# Access Compliance Report

## Public Rights-of-Way

Intersection ID: 30018	Main Street: W_MALLARD_CREEK_CHURCH_DR	Cross Street: BERKELEY_PLACE_DR	Location: NW
ADA ID: E1194C04CE04	Ramp Type: Perp	Initial Pass/Fail: Fail	Overall Compliance: No
Severity Score: 37.5			
Codes/Mitigation Info/Possible Solution		Field Measurements/Component Compliance

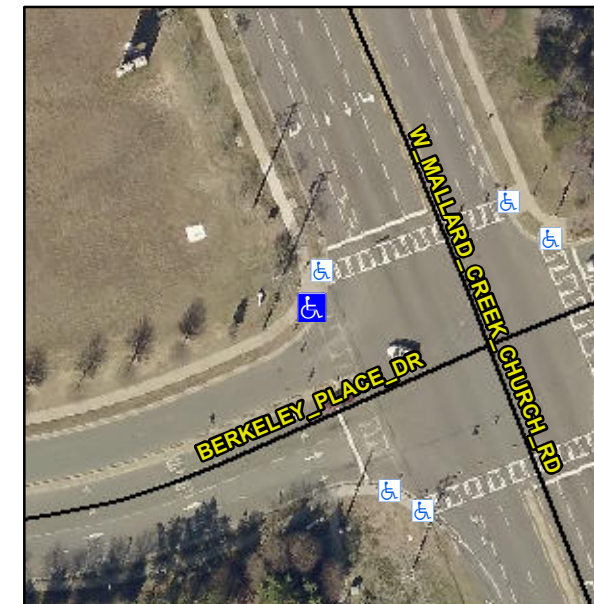
**Remove & Replace Entire Ramp.**

**R304.2.2, R304.5.3**

Compliance	Description	Data	Compliance	Description	Data
N/A	Ramp Length (in)	72.0	No	Ramp Slope (%)	20.0
Yes	Ramp Width (in)	48.0	No	Ramp XSlope (%)	6.1
N/A	Flare Type LT	N/A	N/A	Flare Type RT	N/A
N/A	Flare Slope LT (%)	N/A	N/A	Flare Slope RT (%)	N/A
N/A	Flare Traversable LT?	N/A	N/A	Flare Traversable RT?	N/A
N/A	Landing Length (in)	N/A	N/A	DWS Provided?	N/A
N/A	Landing Width (in)	N/A	N/A	DWS Contrast?	N/A
N/A	Landing Slope (%)	N/A	N/A	DWS Length (in)	N/A
N/A	Landing X Slope (%)	N/A	N/A	DWS Full Width?	N/A
N/A	Landing Curb? (Y/N)	N/A	N/A	DWS Offset (in)	N/A
N/A	Shared Landing?	N/A			
N/A	Gutter Ponding?	N/A	N/A	Gutter Slope (%)	N/A
N/A	Gutter Lip Ht (in)	N/A	N/A	Gutter X Slope (%)	N/A
N/A	Painted X Walk1?	Yes	N/A	Painted X Walk2?	N/A
	X Walk 1 Direction	To S		X Walk 2 Direction	N/A
N/A	X Walk 1 Width (in)	112.0	N/A	X Walk 2 Width (in)	N/A
	X Walk 1 Slope (%)	1.0		X Walk 2 Slope (%)	N/A
	X Walk 1 X Slope (%)	6.3		X Walk 2 X Slope (%)	N/A
